Access Compliance Report

Public Rights-of-Way

(Curb Ramps)

Intersection ID: 3052	Main Street: FOX_GLEN_RD	Cross Street: GLENOVER_CR	Location: S
ADA ID: C0B0EB9AD2A3	Ramp Type: Perp	Initial Pass/Fail: Fail	Overall Compliance: No
Severity Score: 26.25			
Codes/Mitigation Info/Possible Solution		Field Measurements/Component Compliance

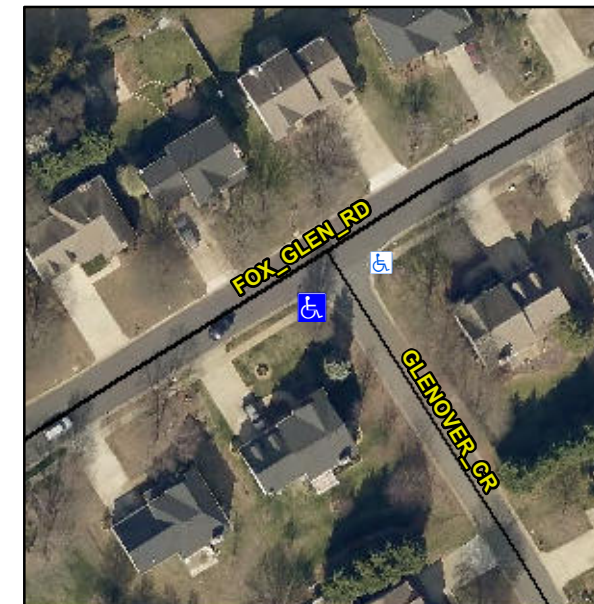
Not Found, R304.2.2, R304.5.3

Compliance	Description	Data	Compliance	Description	Data
N/A	Ramp Length (in)	18.0	No	Ramp Slope (%)	12.7
Yes	Ramp Width (in)	48.0	No	Ramp XSlope (%)	2.7
N/A	Flare Type LT	N/A	N/A	Flare Type RT	N/A
N/A	Flare Slope LT (%)	N/A	N/A	Flare Slope RT (%)	N/A
N/A	Flare Traversable LT?	N/A	N/A	Flare Traversable RT?	N/A
N/A	Landing Length (in)	N/A	N/A	DWS Provided?	N/A
N/A	Landing Width (in)	N/A	N/A	DWS Contrast?	N/A
N/A	Landing Slope (%)	N/A	N/A	DWS Length (in)	N/A
N/A	Landing X Slope (%)	N/A	N/A	DWS Full Width?	N/A
N/A	Landing Curb? (Y/N)	N/A	N/A	DWS Offset (in)	N/A
N/A	Shared Landing?	N/A			
N/A	Gutter Ponding?	N/A	N/A	Gutter Slope (%)	N/A
N/A	Gutter Lip Ht (in)	N/A	N/A	Gutter X Slope (%)	N/A
N/A	Painted X Walk1?	No	N/A	Painted X Walk2?	N/A
	X Walk 1 Direction	To NE		X Walk 2 Direction	N/A
N/A	X Walk 1 Width (in)	N/A	N/A	X Walk 2 Width (in)	N/A
	X Walk 1 Slope (%)	1.0		X Walk 2 Slope (%)	N/A
	X Walk 1 X Slope (%)	6.9		X Walk 2 X Slope (%)	N/A

Remove & Replace Entire Ramp.
